1.a General Length Definition (SLF 53/5, annex 4, issue No. 1)

TM Conv CG Round 1 Questionnaire Rev 0 30Mar2012
Issue 1 – Length Definition

Examples of application of “1 in 4” rule

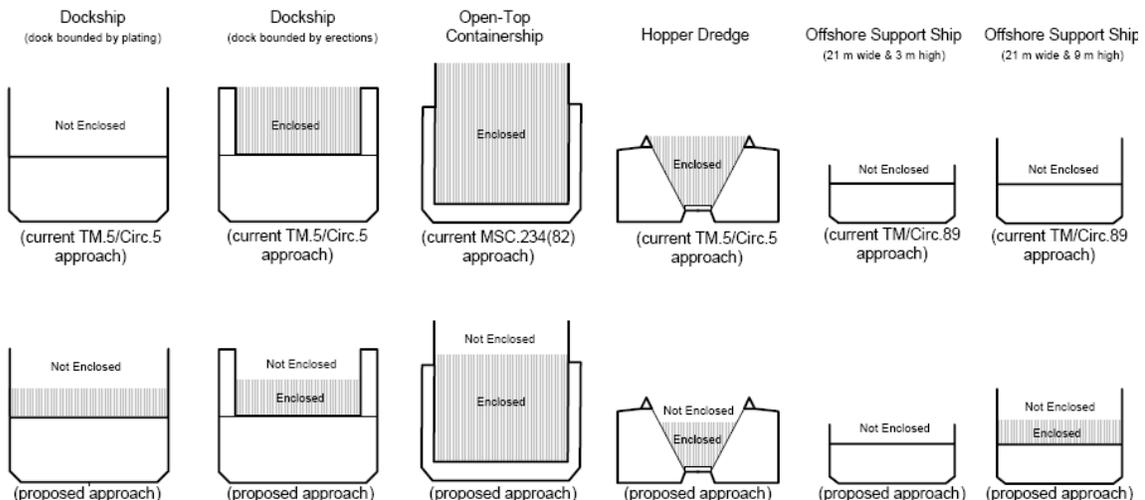
United States (CG Round 1) Establish novel craft provisions to address the large high-sided spaces on any ship-type, including open-top containerships, as if the upper portion of that space is not enclosed, along the lines of an aspect ratio (e.g., “1 in 4”) rule based on the height (vertical direction) and width (transverse direction) of the space, regardless of whether or not there is a deck above. This is to reflect the relative “openness” of such space, subject to a restriction to openings less than a certain percentage (e.g., 50%) of the ship’s breadth (B), to avoid conflicts with how the TM Convention treats space beneath “true” deck openings. Restrictions on the amount of GT reduction (e.g., 30%) are envisioned to preclude “abuse”. Make corresponding changes to the TM.5/Circ.5 interpretations on hopper barges, dockships, etc. This would also eliminate the need for special novel craft provisions for offshore support (supply) vessels (OSVs). See illustrations below and on next page.

**Proposed “1 in 4” rule
for treatment of large uncovered spaces**

Enclosed
 Semi-Open spaces which are treated as enclosed spaces and included in the total volume of all enclosed spaces (V)

Hatch coaming

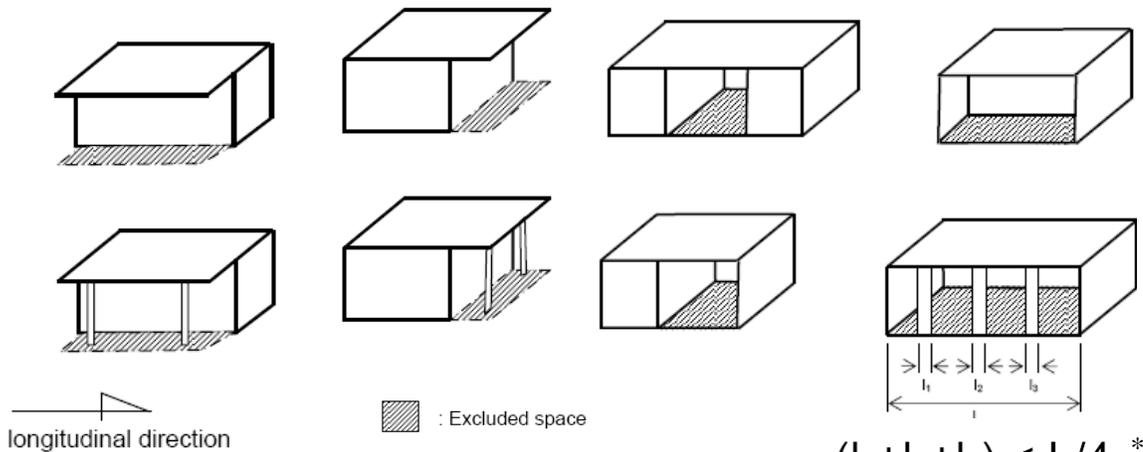
- a. Regulation 2(5)(b) can be applied not only to erections extending from side to side of ship, but also to erections such as structures that do not extend from side to side. For example, if the space around the hatch coaming pictured below exceeds 1m^3 and 1m^2 , it is appropriate to apply regulation 2(5)(b), and the space can be excluded.

* Considering that the vertical plate could obstruct the opening, the total area of stanchions could be restricted to not exceed 25% of the opening area.

3.i Revolving Door Within a Covered Space (Italy)

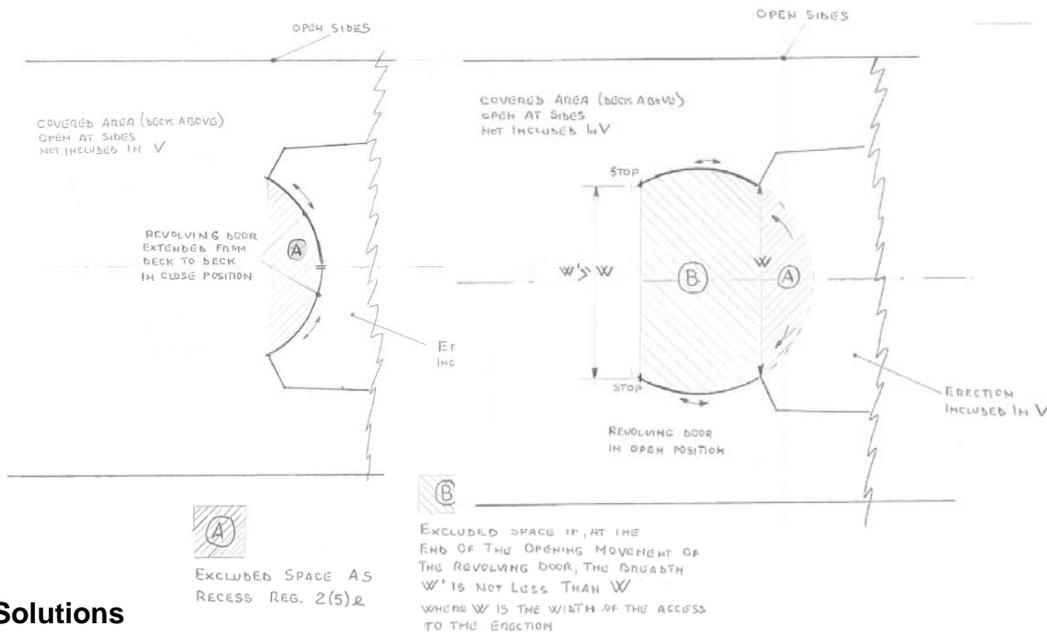
Description of Issue In figure A (left) is showed a revolving door, extended from deck to deck in a covered area, in closed position. In figure B (right) is showed the revolving door in open position. This position creates a new space B, covered and protected by sides

Italy (CG Round 1) In our opinion, it is necessary to clarify that if the breadth W at the maximum opening movement of the revolving door is not less than W , the width of the access to the erection, the spaces $A+B$ are not included in Total Volume for Gross Tonnage calculation. Our opinion is supported by the fact that the revolving door should not be considered as portable partitions or bulkheads.

4.e Fitting of Grates Over Deck Openings (Italy - CG Round 1)

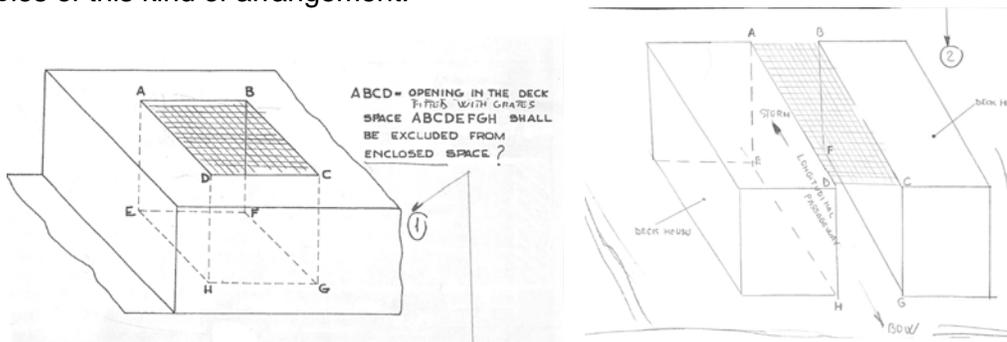
Description of Issue Spaces that can be excluded in accordance to the Regulation 2(5)(d), are frequently fitted with grates (e.g. in order to allow crossing). Also longitudinal passageways between deck houses are sometimes fitted with grates on the top. The following figures provide an examples of this kind of arrangement.

Italy (CG Round 1) In our opinion, it is necessary to clarify that in the cases described in the above, grates should be considered as means of closure for the purpose of the a.m. regulation and the space below the grate shall not be considered as excluded space.

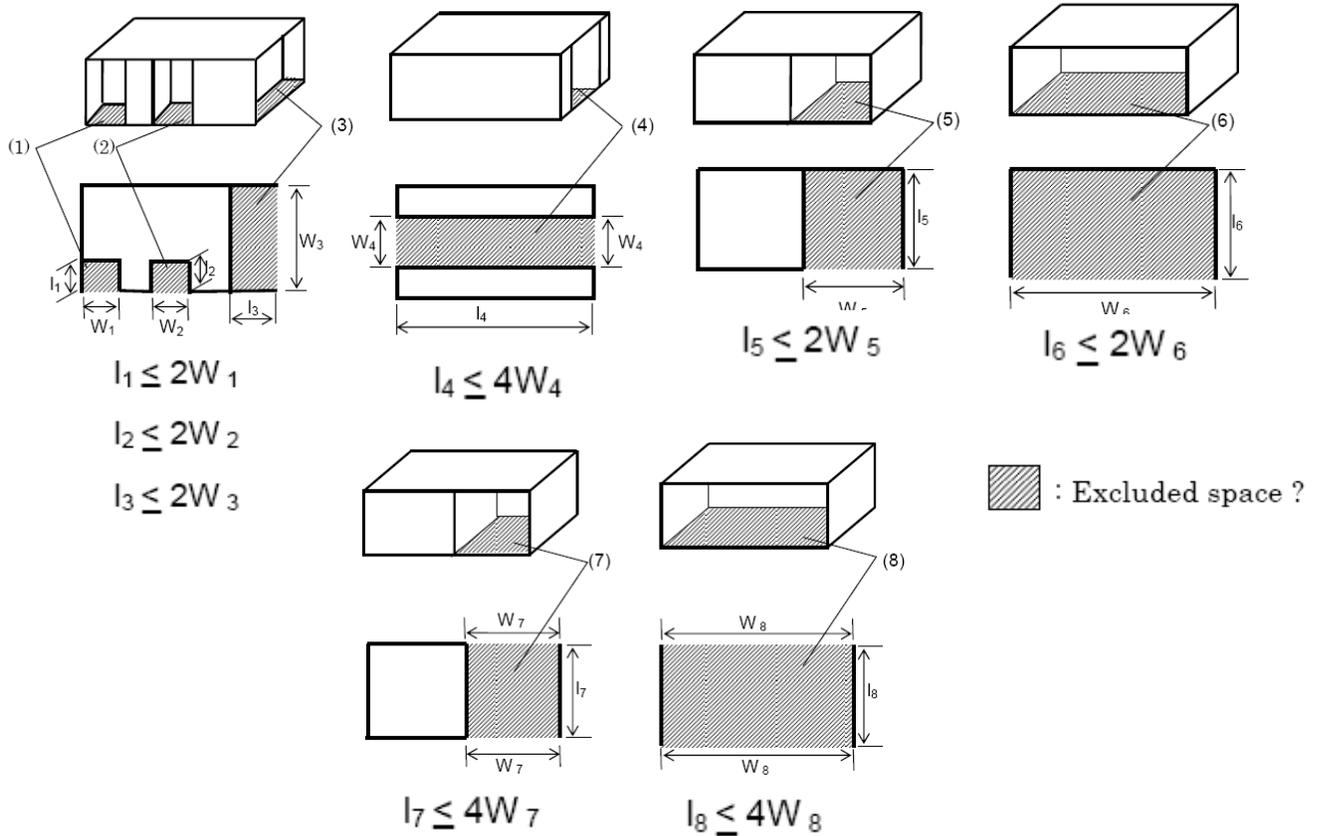
Japan (CG Round 1) The definition of recess is required (see following figures). According to an unofficial international experts meeting in 1990, 6 of the countries considered that (3) in the figures could be excluded. 5 of the countries considered that (4) in the figures could be excluded.

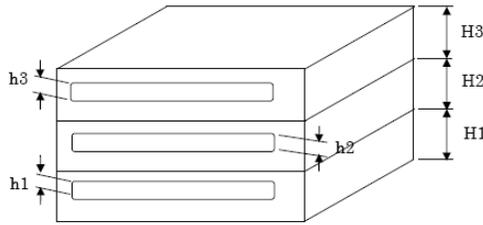
Japan (CG Round 1) The height of the opening should be evaluated by the height between the continuity/complete decks in each tier. The tier should be defined as the space between decks/covers.

H1, H2 and H3 are heights of each tier
 h1, h2 and h3 are heights of opening in each tier

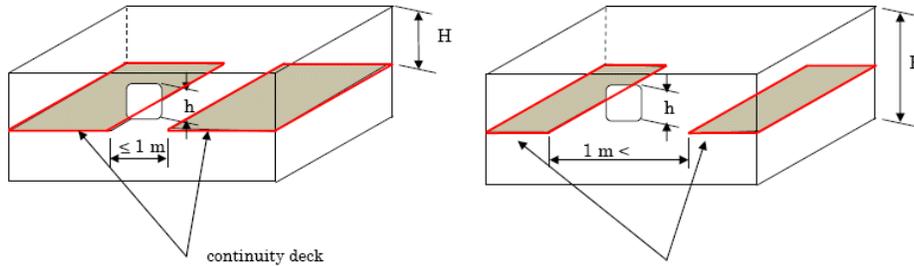
- a. A deck in a deck which extends side to side for the breadth of the structure and is in excess of 1 meter in length should be a discontinuous/stepped deck (reference TM.5/Circ.5 1.1).

H is height of the tier
 h is height of opening in tier

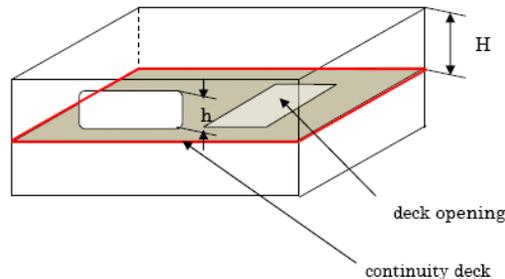
- b. A deck opening which does not extend side to side for the breadth of the structure should be a continuous/complete deck (reference TM.5/Circ.5 1.3).

H is height of the tier
 h is height of opening in tier

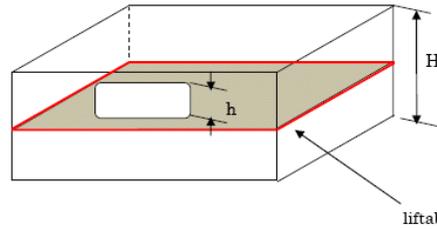
c. Liftable decks or removable decks should not be continuous/complete decks

H is height of the tier
 h is height of opening in tier

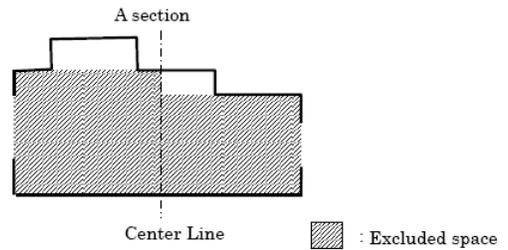
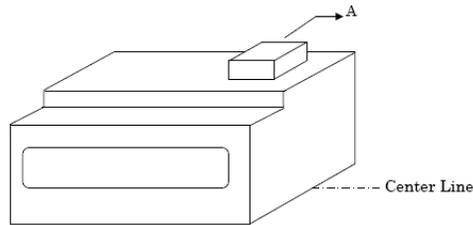
d. If there is a step or protrusions in the deck, the top of the excluded space should be the lowest level of the superior/upper deck.

5.f Restrictions on Excluding Space Below Uncovered Openings (SLF 53/5, annex 4, issue No. 20)

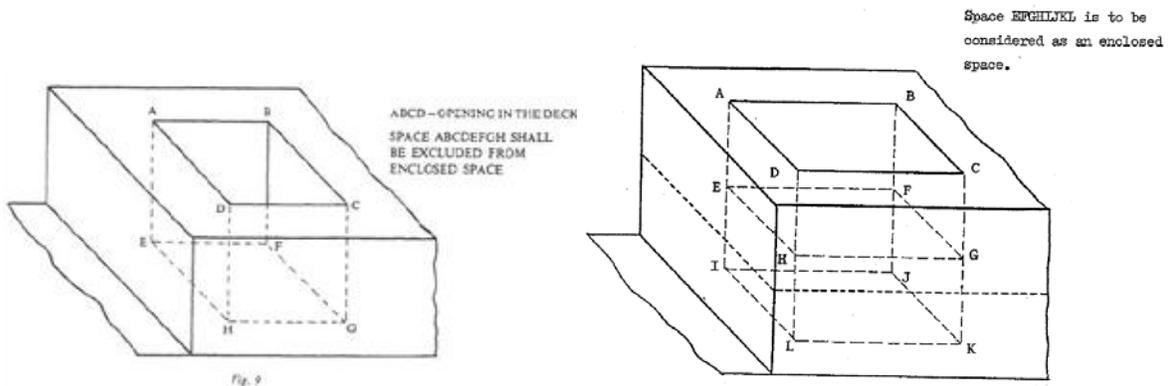
Panama (CG Round 1) Only the open space in the above figure lettered ABCDEFGH should be excluded from volume calculations.

Figure 1: A ship fitted with spaces between the inner skin and the outer shell to fill air for buoyancy

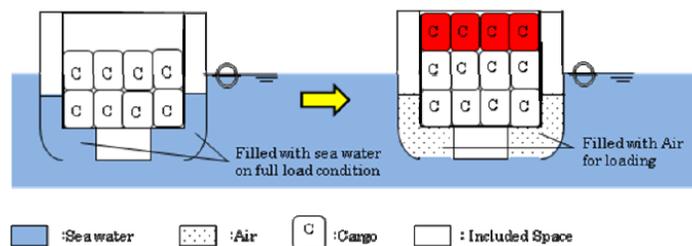
Description of Issue Some ship designs have been developed to obtain additional buoyancy or an additional cargo capacity with less gross tonnage, making use of regulation 6(3). Examples of such designs are: 1) ships with open bottom spaces between the inner skin and outer shell to hold air to gain additional buoyancy (figure 1); and 2) ships with cargo spaces between cross-deck structures with gratings openings to the sea (figure 2). The existing unified interpretations do not cover the situation. The volumes of spaces open to sea in the ship designs mentioned in the previous paragraph are dominant, compared against the total volume of the ships. Therefore, lack of unified interpretations and inconsistent treatment by Administrations are to lead to inconsistent implementation of the TM Convention, and allow some designers to attempt to gain certain tonnage reduction by treating spaces as "spaces open to the sea."
